TO: Mills City Council
FROM: Megan Nelms, AICP, City Planner
DATE: March 11, 2025
SUBJECT: Final Plat – Lots 2A & 3A, Sage Addition

Case Number: 25.01 FSP

Lots 2A & 3A, Sage Addition

Boundary Line Adjustment

Lots 2A & 3A, Sage Addition – Boundary Line Adjustment Final Plat

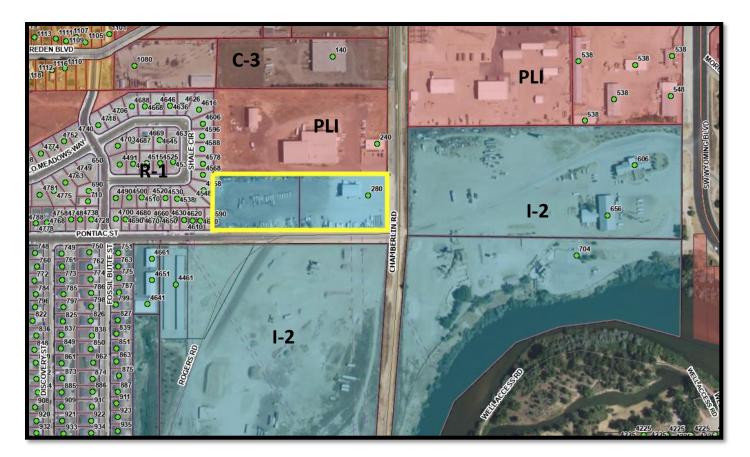
- 1. Submit a signed City of Mills Subdivision Plat application
- 2. Add a 5' general utility easement around the boundary of each lot
- 3. Label the lot line being vacated by the plat.
- 4. Buffalo Meadows Addition is adjacent on the western boundary of the subdivision, not Lot 4, Sage Addition. Re-label and update the calls in the legal description in the Certificate of Dedication.

5. The Dedication shows the acreage of the subdivision is 47.65-acres. Correct to 4.457-acres.

- a. Verify the plat scale is 1" = 60' not 1" = 100'
- b. Verify all line types in the legend match those on the plat face
- c. Revise the plat in the vicinity map and Surveyors Certificate to match the Dedication.

Summary: The plat has been updated to reflect correct line types in the line legend and to include a 10' rear yard general utility easement. The updated plat is included in the packet.
